RHODE ISLAND CONTRACT NO.2014-CH-071

**Broadway Streetscape Improvement Project**

NOTICE TO PROSPECTIVE BIDDERS

ADDENDUM NO. 2 Prospective bidders and all concerned are hereby notified of the following changes in the Plans, Specifications, Proposal and Distribution of Quantities for this contract. These changes shall be incorporated in the Plans, Specifications, Proposal and Distribution of Quantities, and shall become an integral part of the Contract Documents.

ENLARGEMENT AREA 1
SCALE: 1"=10'

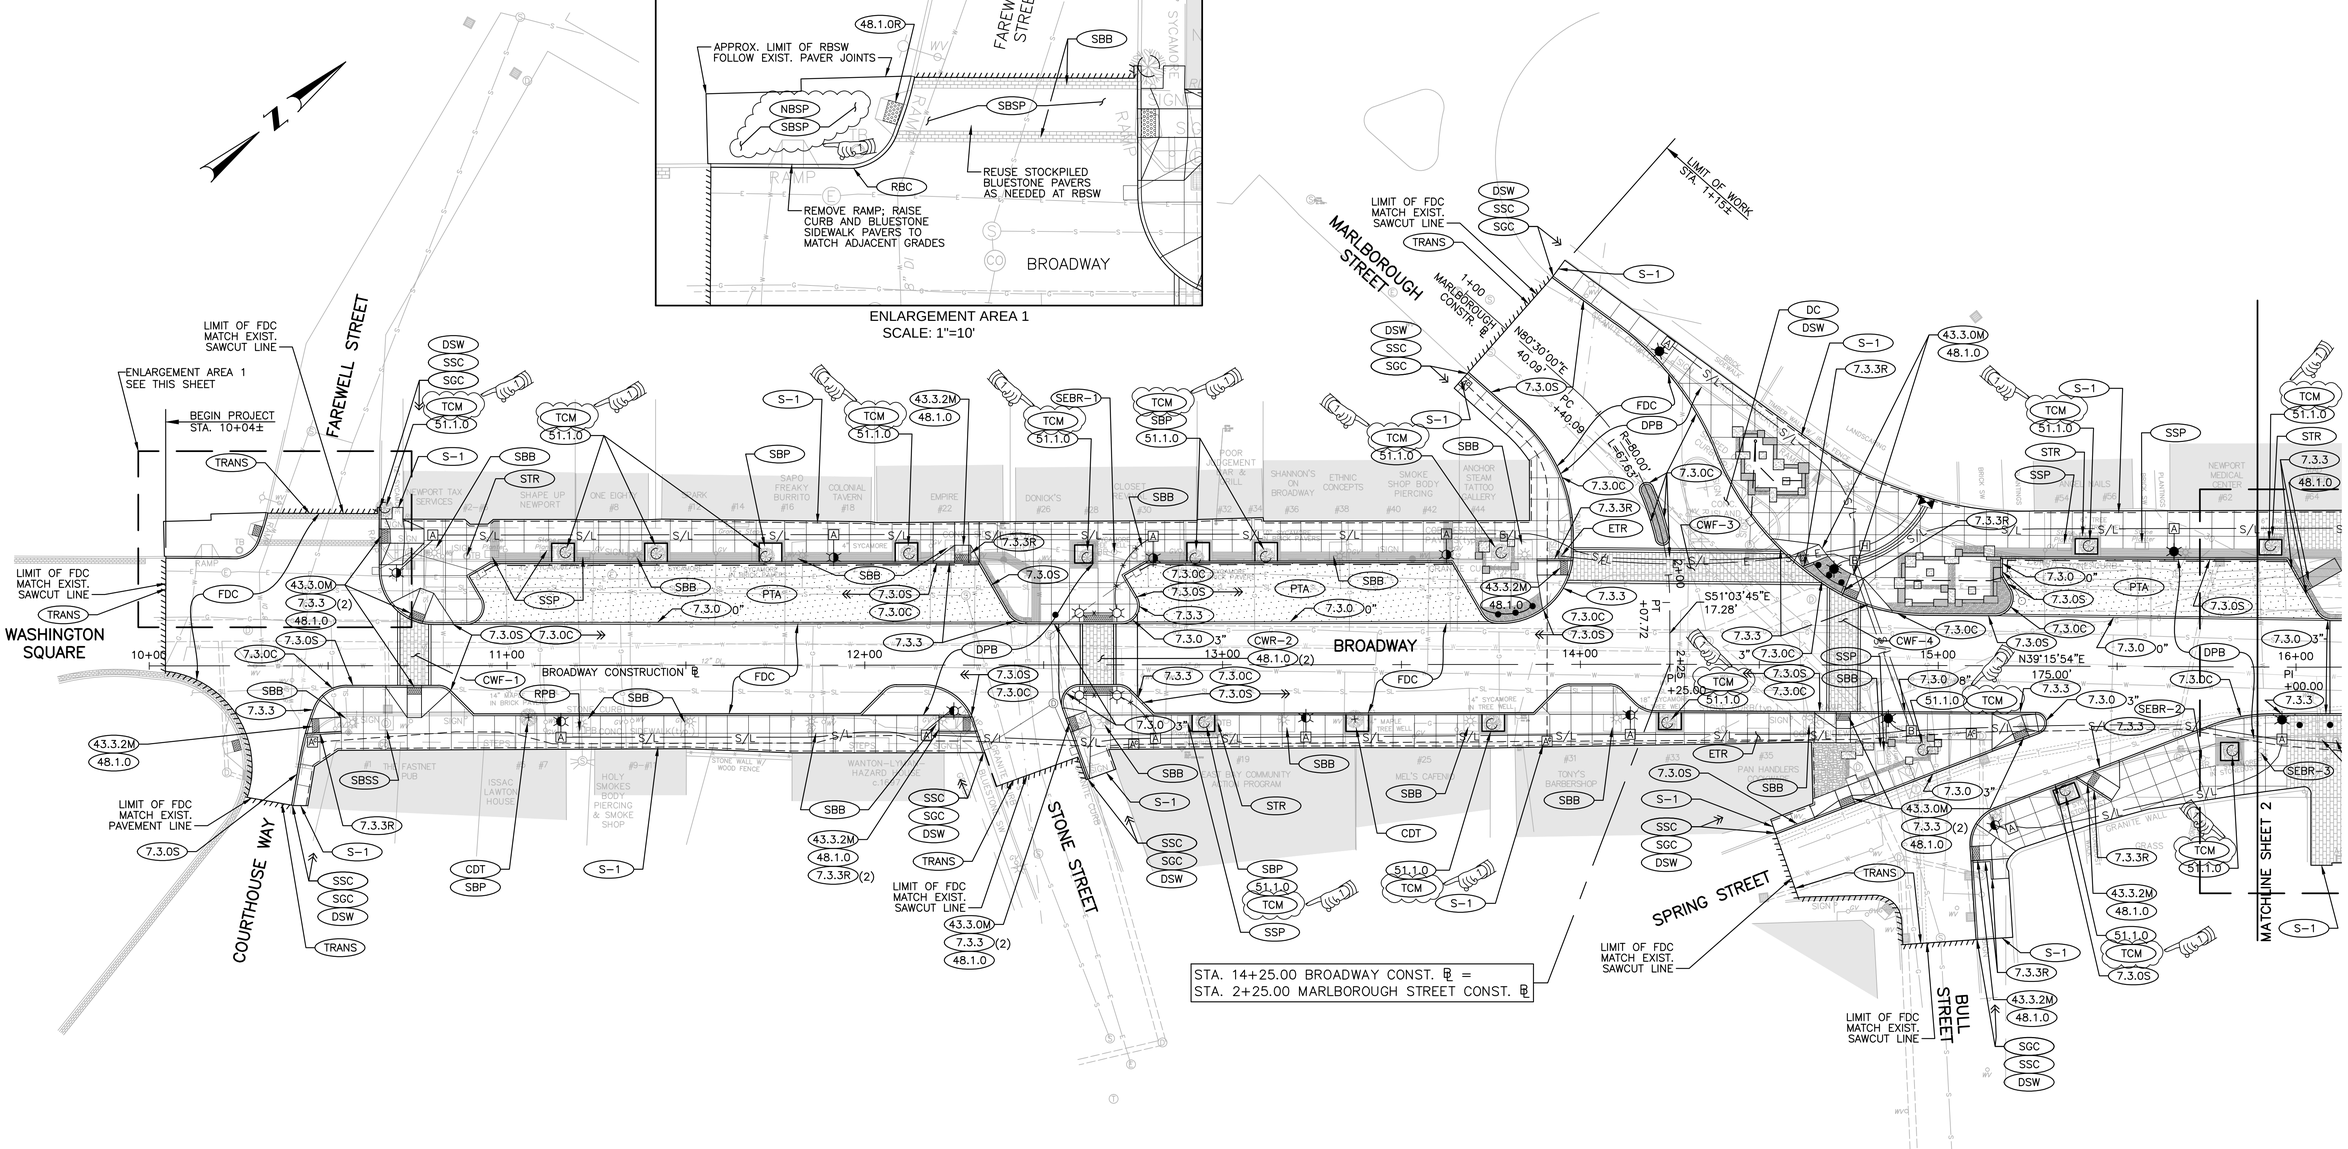
Remove Sheet No. 10 - General Plan No. 1 of 6 in its entirety and replace with revised Sheet No. 10 - General Plan No. 1 of 6(R-1) attached to this Addendum No. 2. Callout for Tree Conservation Measures (TCM) has been added at same locations shown on Landscape Improvement Plans. Callouts have been revised within Enlargement Area 1.

6. SHEET NO. 32 - DRAINAGE AND UTILITY PLAN NO. 3 OF 6

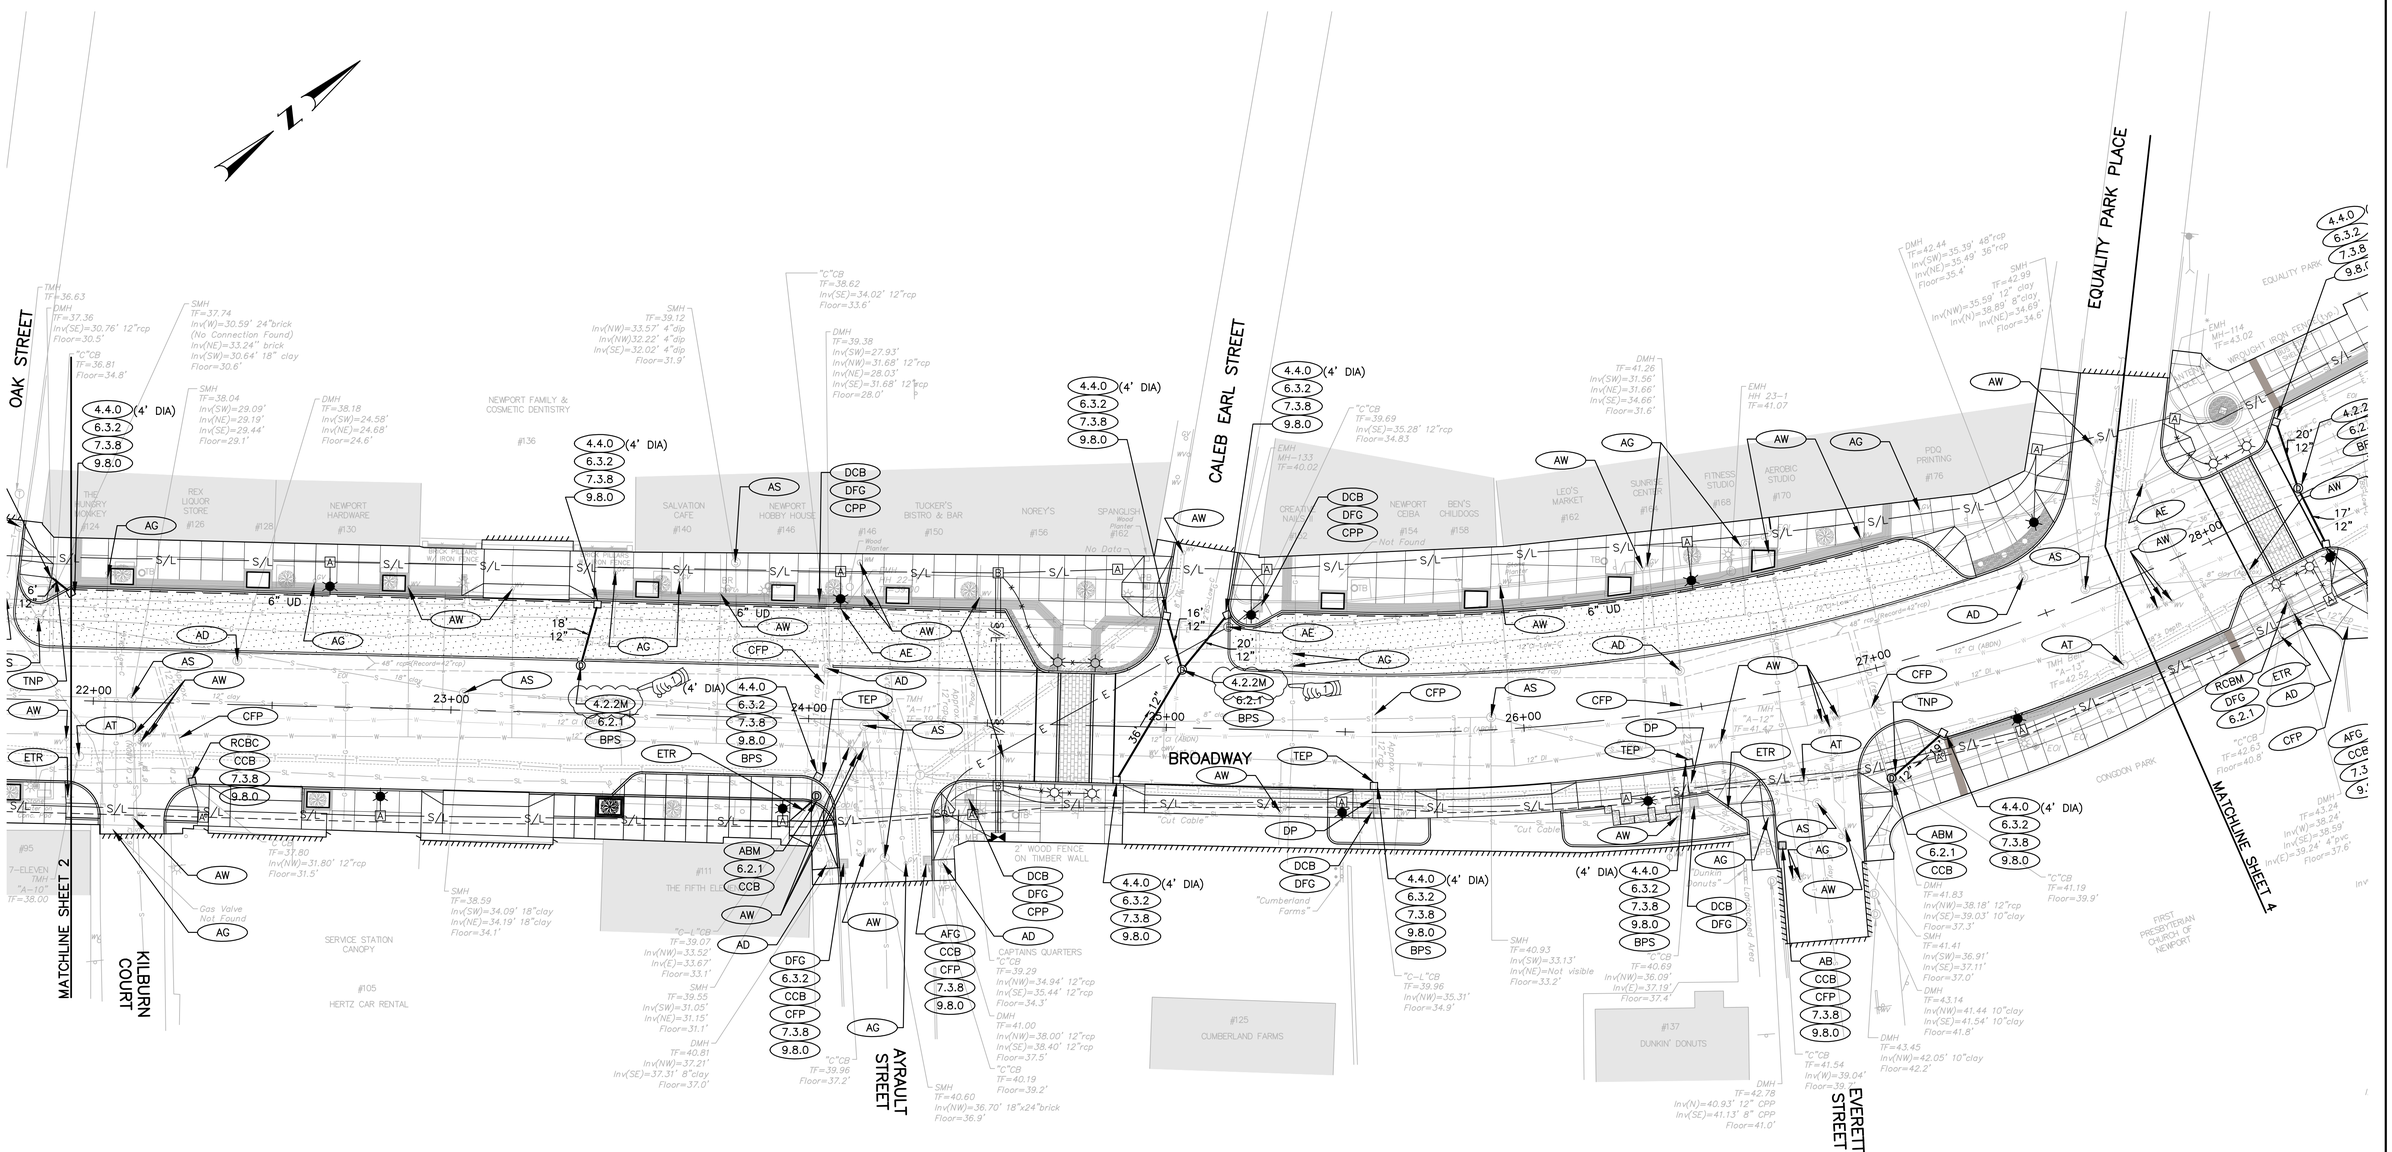
Remove Sheet No. 32 - Drainage and Utility Plan No. 3 of 6 in its entirety and replace with revised Sheet No. 32 - Drainage and Utility Plan No. 3 of 6(R-1) attached to this Addendum No. 2. Manhole has been revised from type 4.2.2 to 4.2.2M @ 2 locations; sta 23+36+/- & sta 25+04 +/-.

7. SHEET NO. 33 - DRAINAGE AND UTILITY PLAN SHEET NO. 4 OF 6

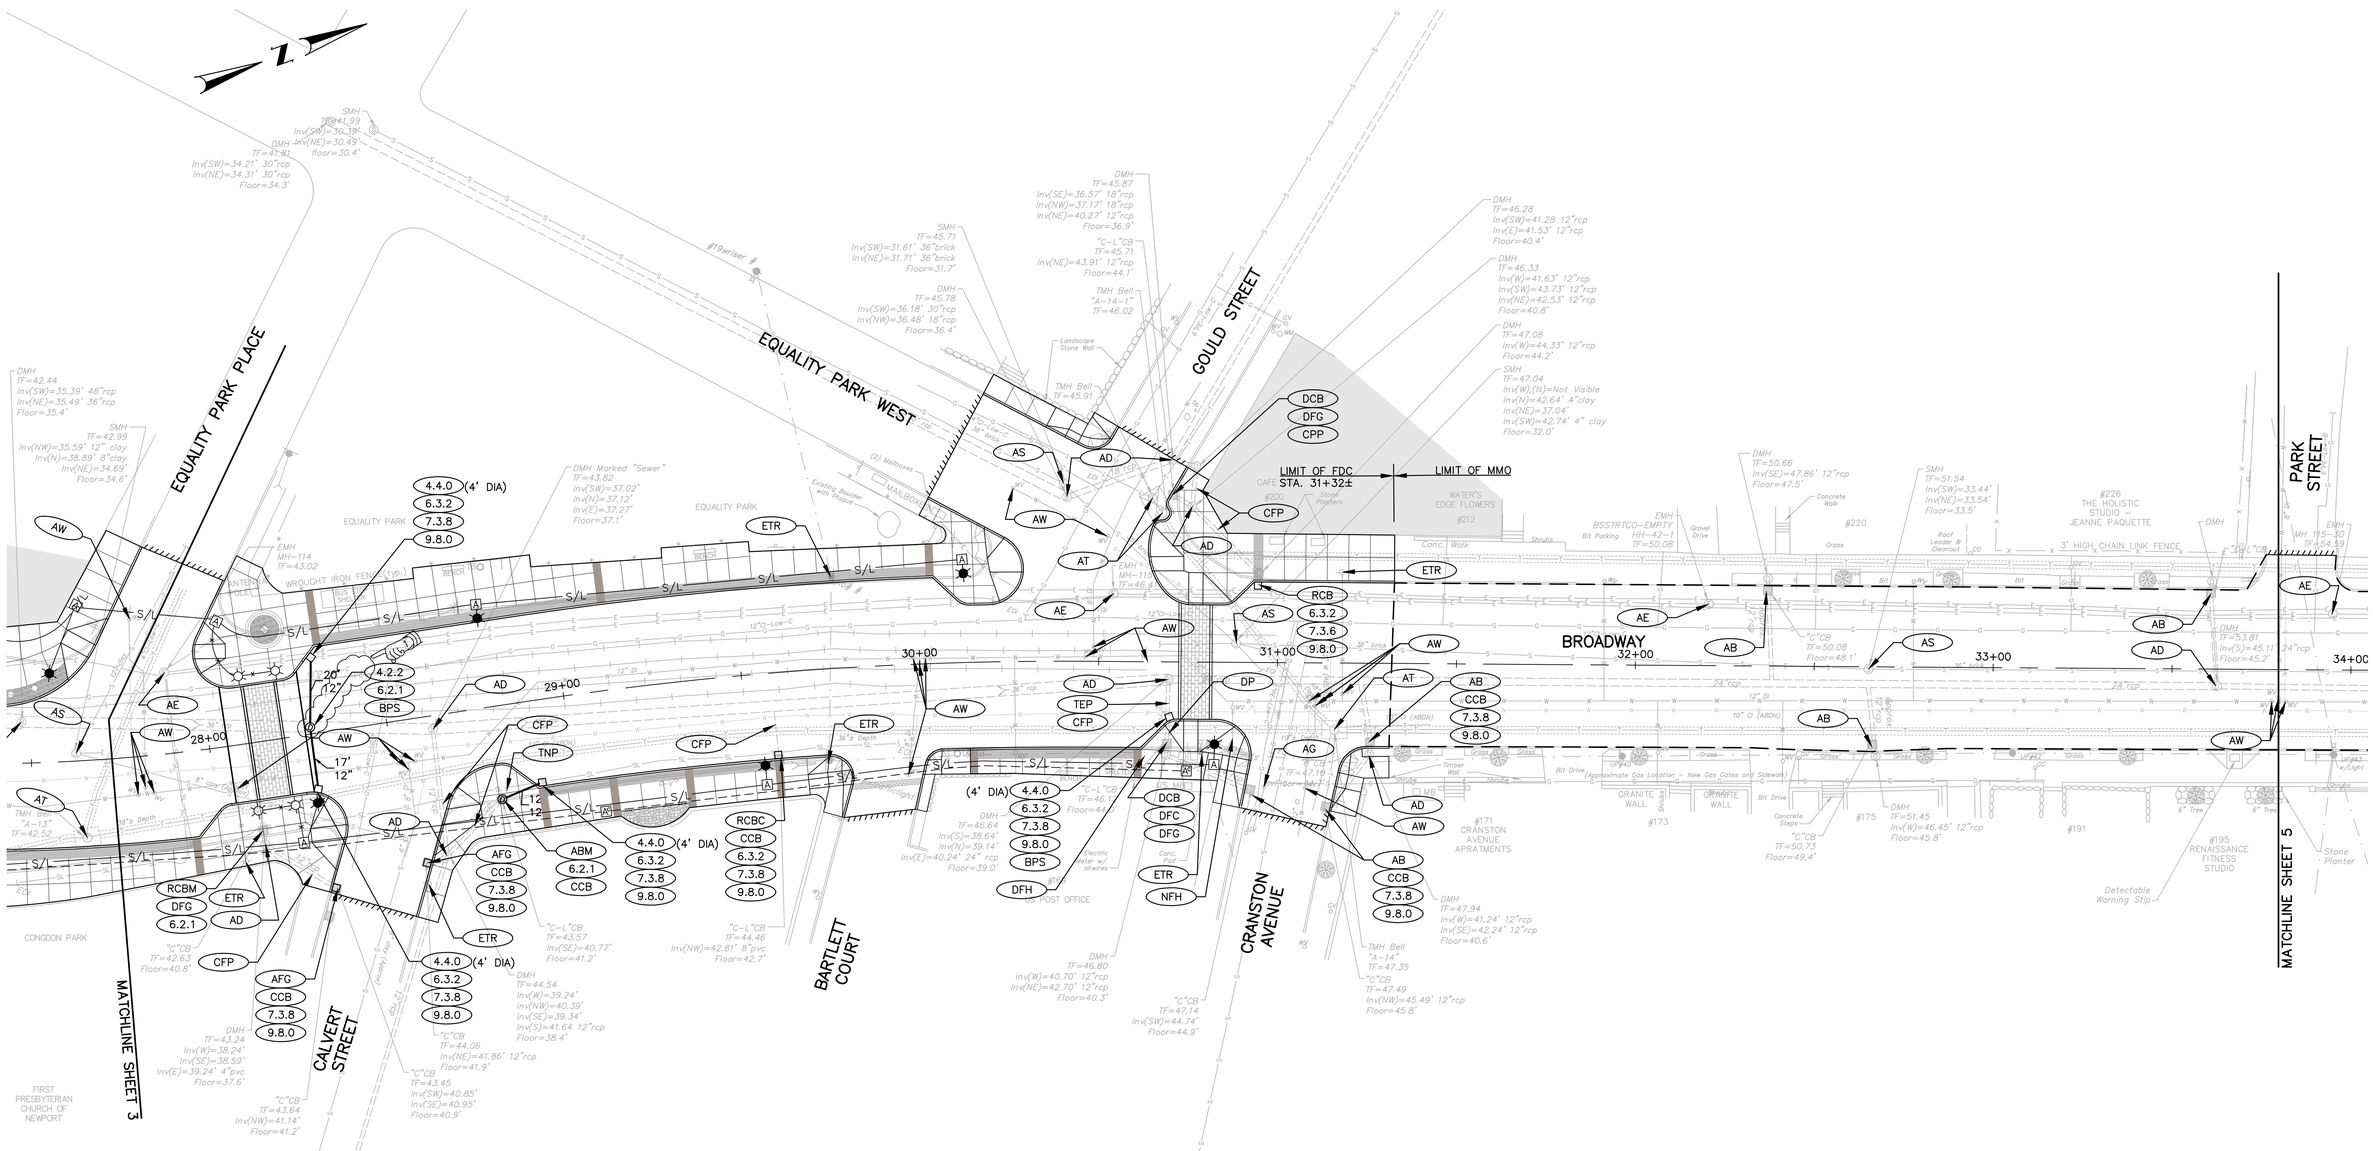
Remove Sheet No. 33 - Drainage and Utility Plan No. 4 of 6 in its entirety and replace with revised Sheet No. 33 - Drainage and Utility Plan No. 4 of 6(R-1) attached to this Addendum No. 2. Leader pointing to Manhole type 4.2.2 has been revised so it points to the proposed structure at sta. 28+29 +/-.

## EP-1 ENLARGEMENT PLAN IN FRONT OF CITY HALL

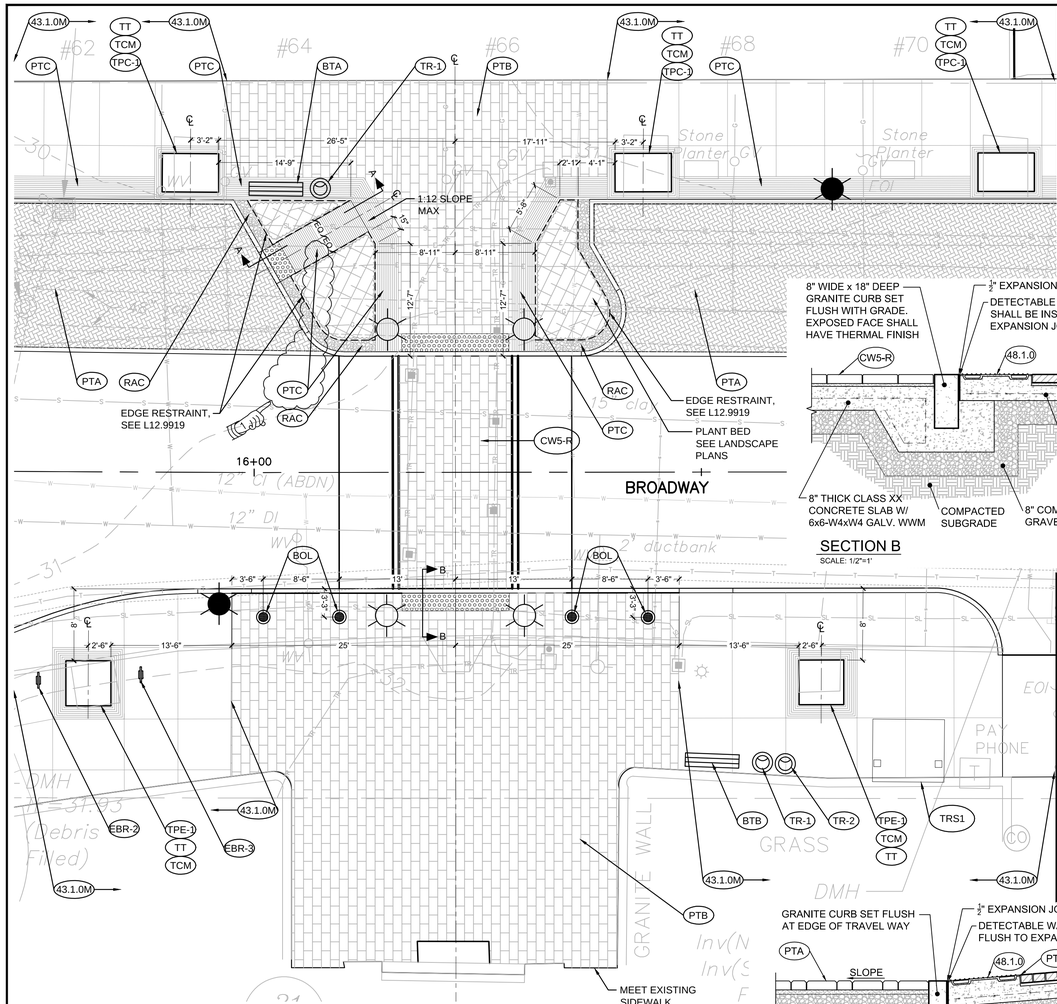
Remove Sheet No. 65 - Landscape Details Sheet No. 2 of 8 in its entirety and replace with revised Sheet No. 5 - Landscape Details Sheet No. 2 of 8(R-1) attached to this Addendum No. 2. Leader to PTC callout in EP-1 has been added.

CSB CUT STONE TYPES
SCALE: 1/2"=1'

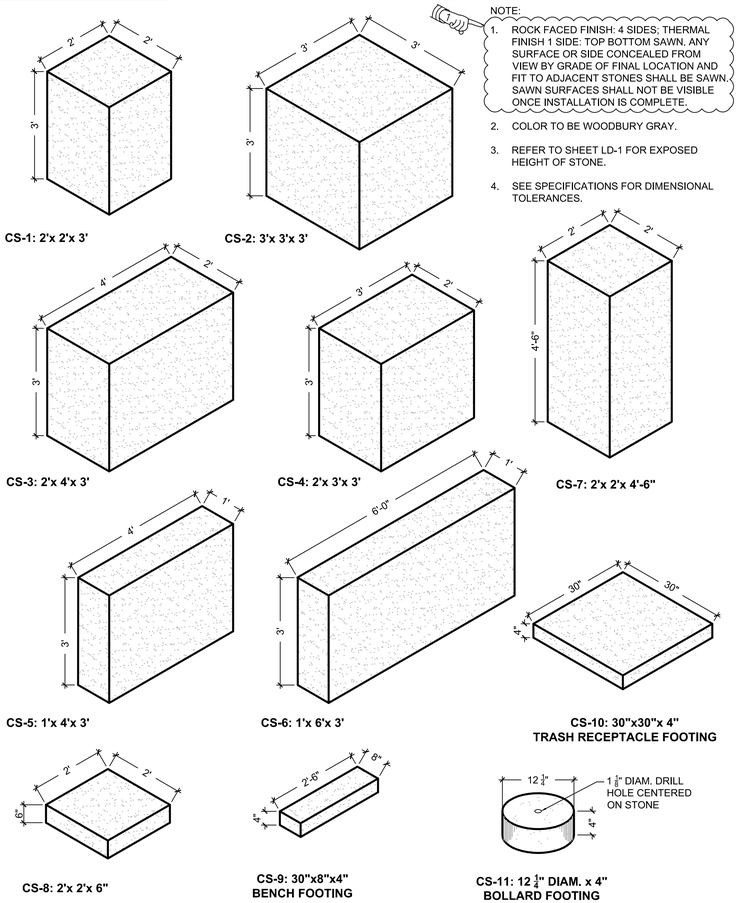
Remove Sheet No. 71 - Landscape Details No. 8 of 8 in its entirety and replace with revised Sheet No. 71 - Landscape Details No. 8 of 8(R-1) attached to this Addendum No. 2. Note #1 in (CSB) "Cut Stone Types" detail has been revised to match specification text

PRECAST 8' MANHOLE WITH 48" MANHOLE STACK (4.2.2(M))
NOT TO SCALE

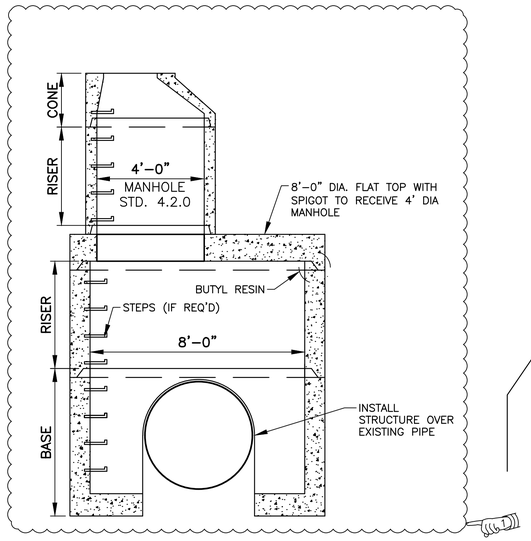
Remove Sheet No. 72 - Construction Details No. 1 of 2 in its entirety and replace with revised Sheet No. 72 - Construction Details No. 1 of 2(R-1) attached to this Addendum No. 2. Detail for "Precast 8' Manhole with 48" Manhole Stack" has been revised.
